01-182269

PERMIT

SEWAGE DISPOSAL SYSTEM
MARYLAND STATE DEPARTMENT OF HEALTH

COMPLETED - NOT APPROVED
10/30/85 CW

PERMIT CARD

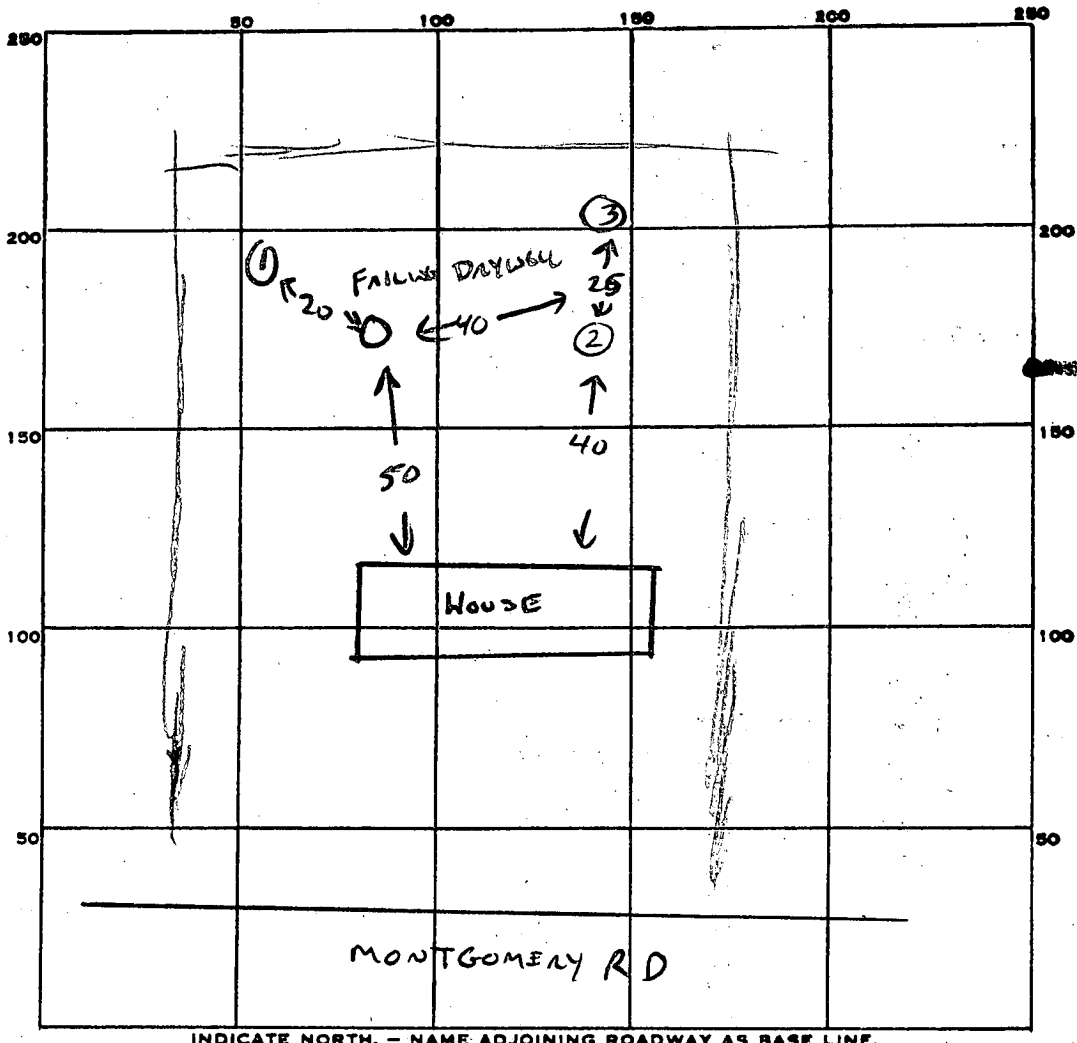
REMARKS EXISTING DAYWELL FOR 25 YEARS SEEMED TO WORK OK. 2 ELDERLY PEOPLE IN HOUSE.
3 HOLES DUG 12' DEEP ALL 3 HAD SANDY CLAY TOP TO BOTTOM.
1 HOLE TESTED - NO PERCOATION IN 2 HOURS.
NO REPAIR FEASIBLE, PUBLIC SEWER ANTICIPATED IN 5 YEARS.
RECOMMEND PUMPING DAYWELL AS NEEDED, IF THAT DOES NOT WORK OUT
THEN RECONSIDER REPAIR POSSIBILITIES.
